Planning & Zoning Board Meeting

ZONING MEMORANDUM

Meritage Homes- Elevation/ Architectural Plans Hillside Groves (The Reserve PUD) Applicant: Meritage Homes

Meritage Homes 4R10 (Formerly Daphne)

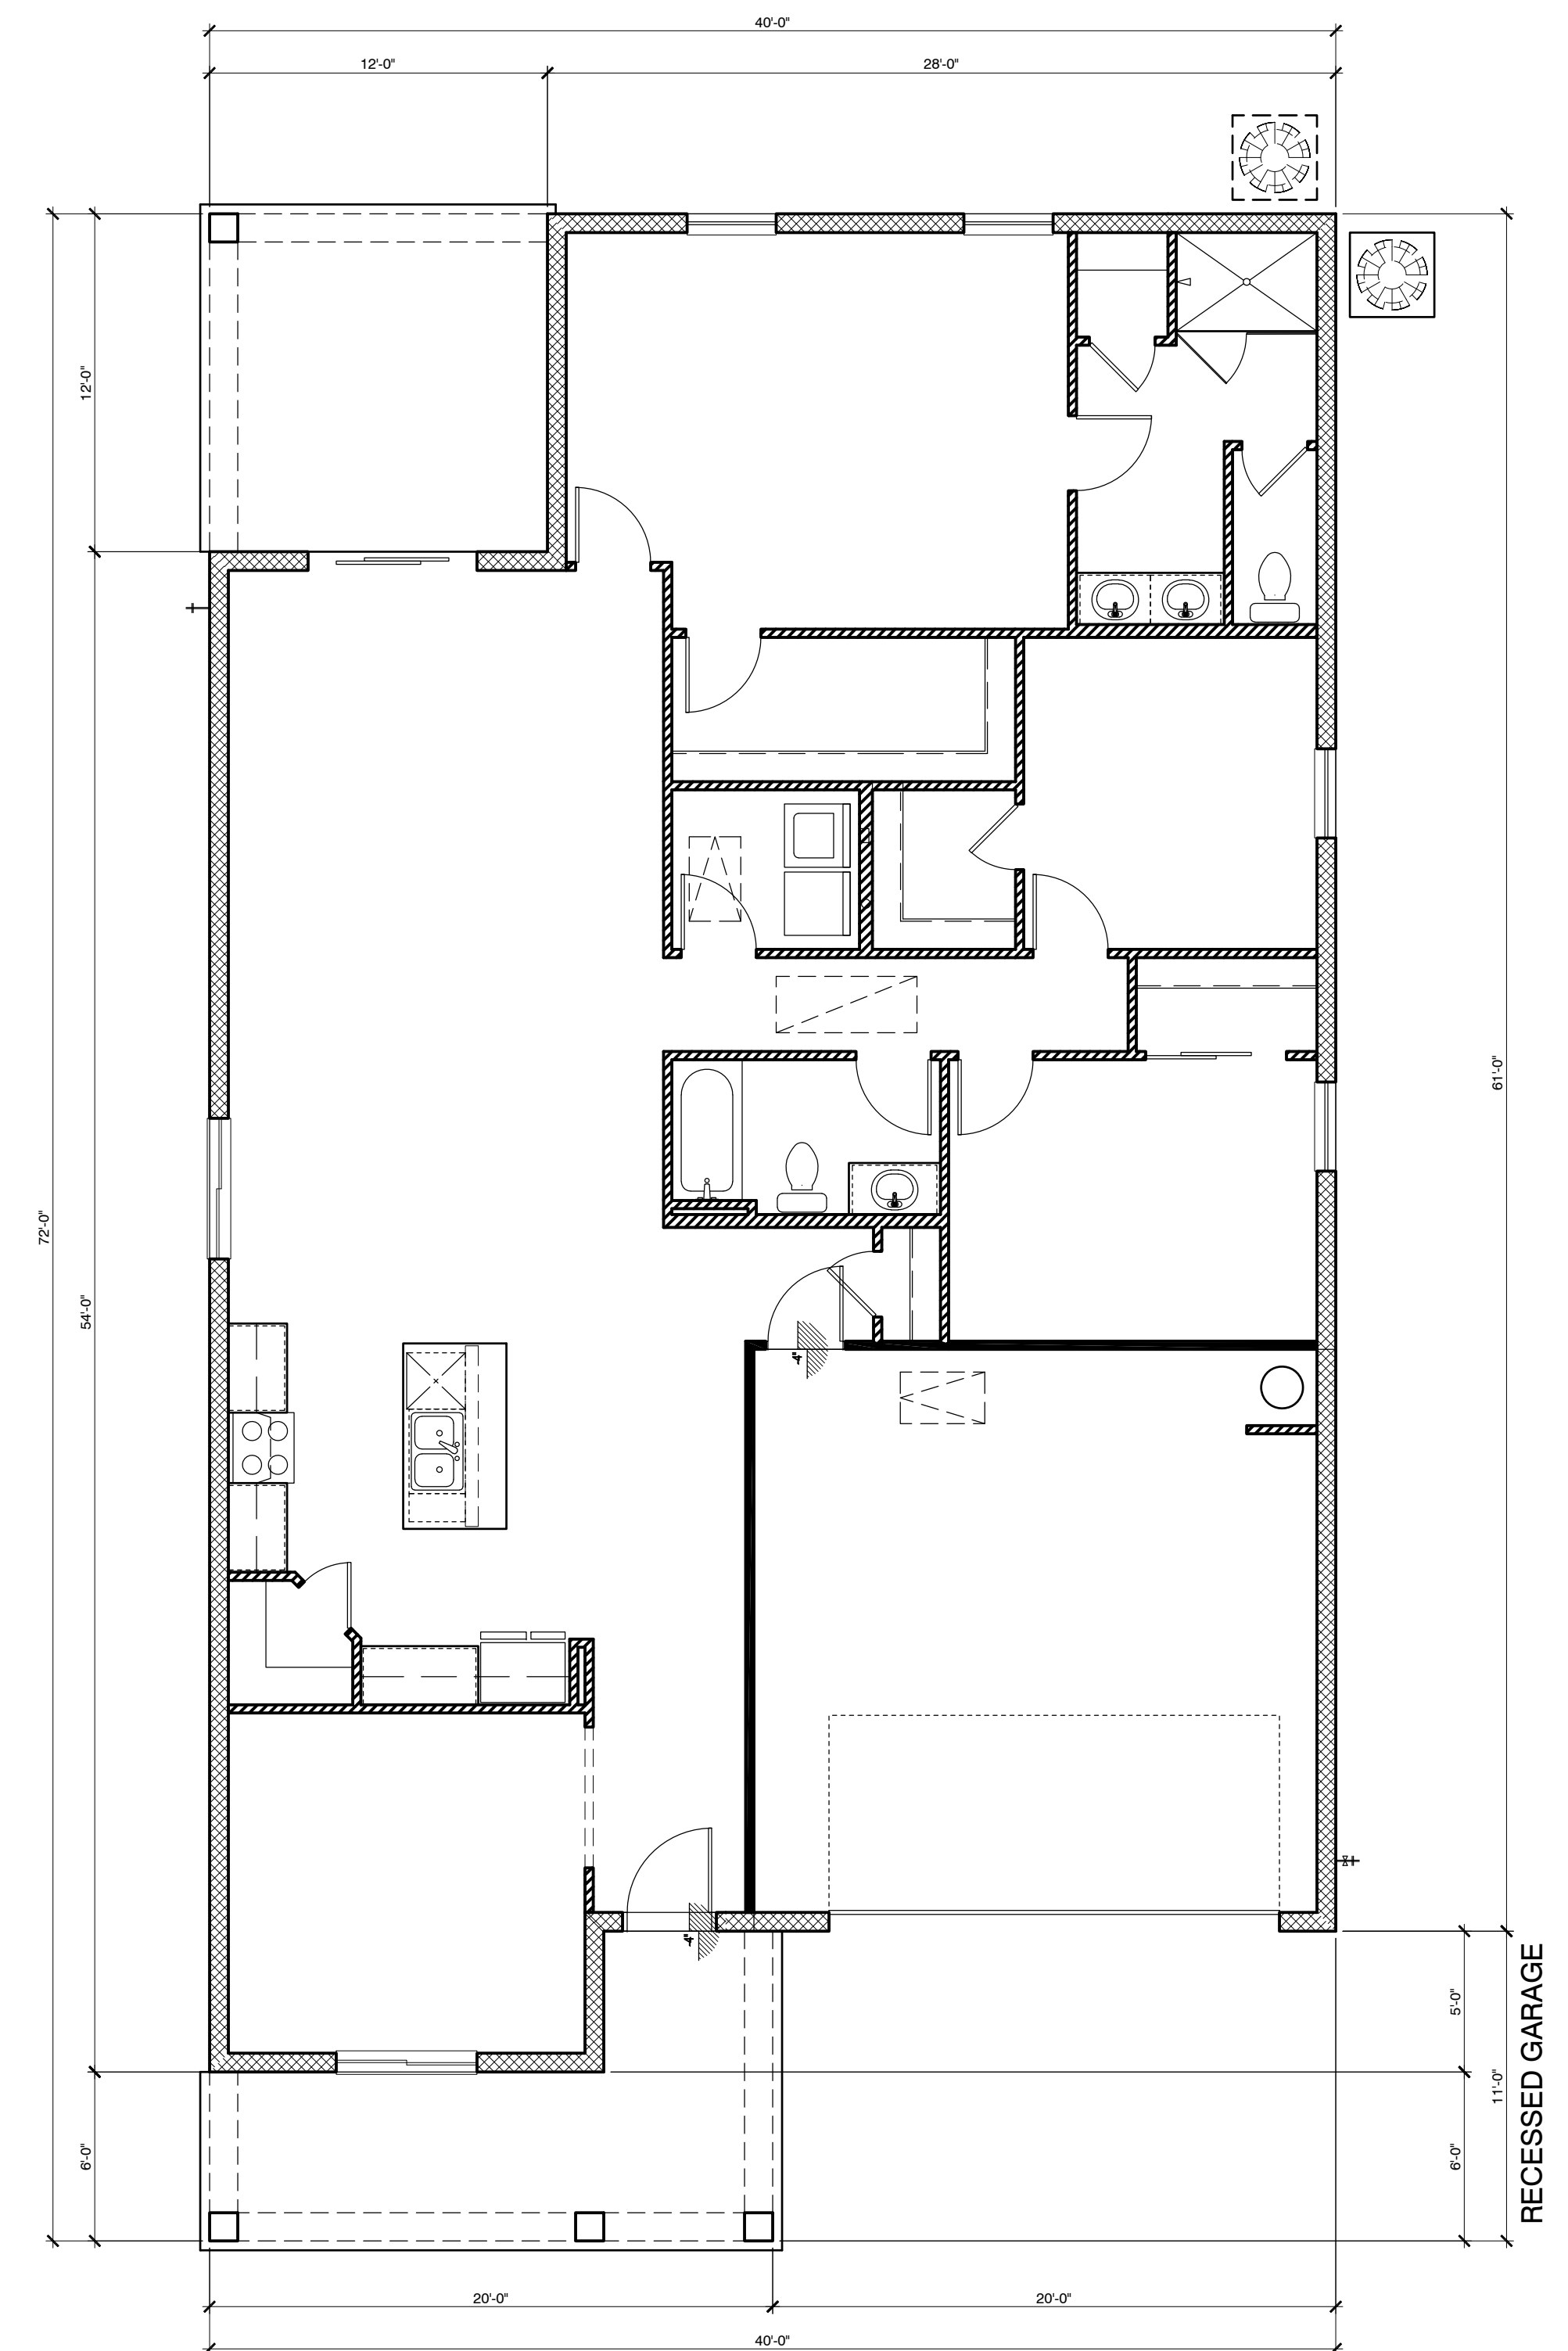
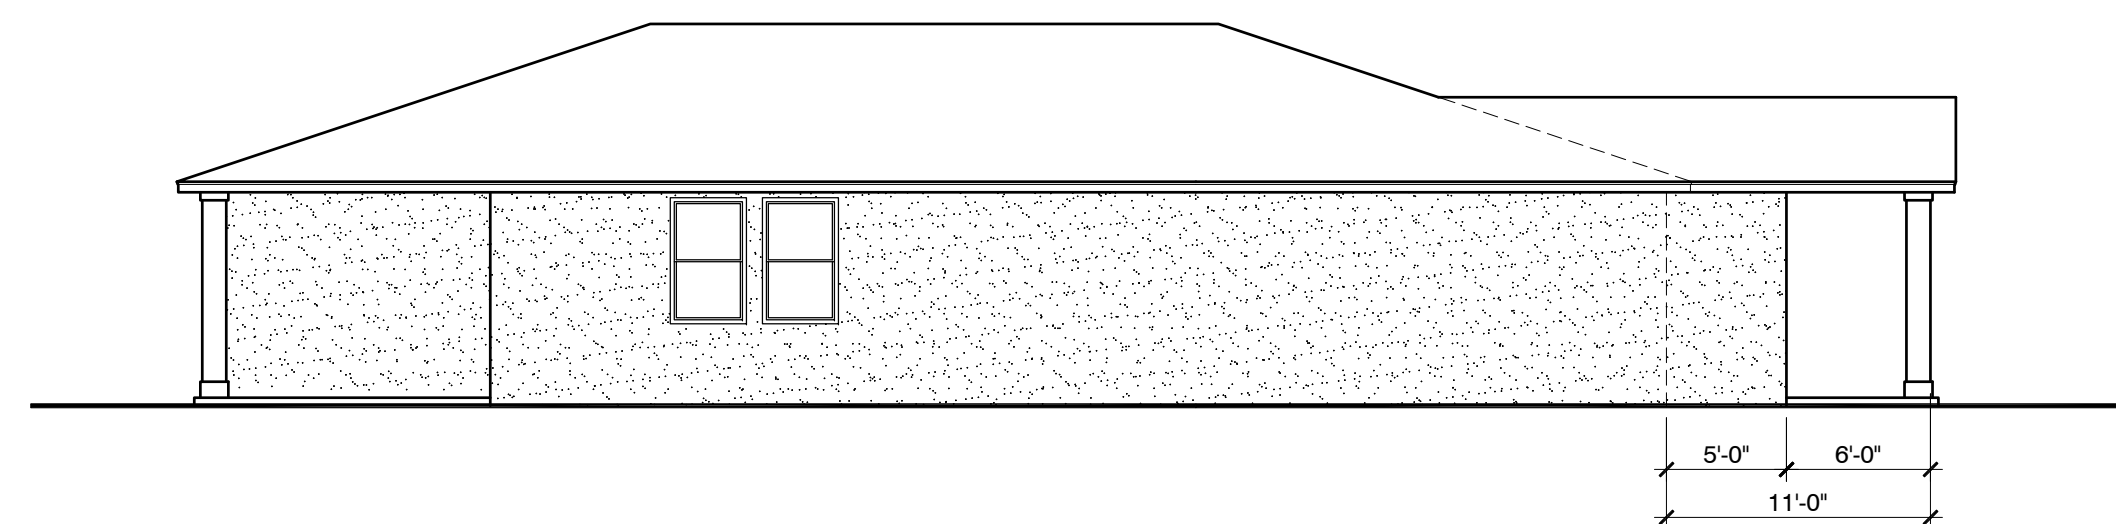
The proposed models appear to provide porches and recessed garages consistent with LDC Sec. 4.06.02 (A) (2) and (3). Additional detail on the porches would be helpful though to determine if they are at or above grade or have articulation designating them as usable front porches. As an example, none of the porches show railings as part of the design.

The proposed elevations show what appears to be stonework and varying materials on the models, however no product types, colors or materials are identified on the plans. The elevation plans need to be revised to demonstrate and specify materials to ensure that they are consistent with the following LDC Sections which state:

The proposed elevations do not identify the roof materials to be used nor detail on eave design. The plans need to be revised to demonstrate and specify roof materials and eaves detail to ensure that they are consistent with the following LDC Sections:

The application provides some of these details but not all that are required for each of the facades. Consistent with LDC Sec. 4.06.03, the plans need to be revised to show and label the front, side, and rear facade elevations for each model and identify the specific architectural details on each façade, demonstrating how they are consistent with the type and quantity required in LDC Sec. 4.06.03 (C).

Recommendation: The model elevations should be revised consistent with the requirements identified in the review comments below and be brought back to the Planning and Zoning Board for consideration.
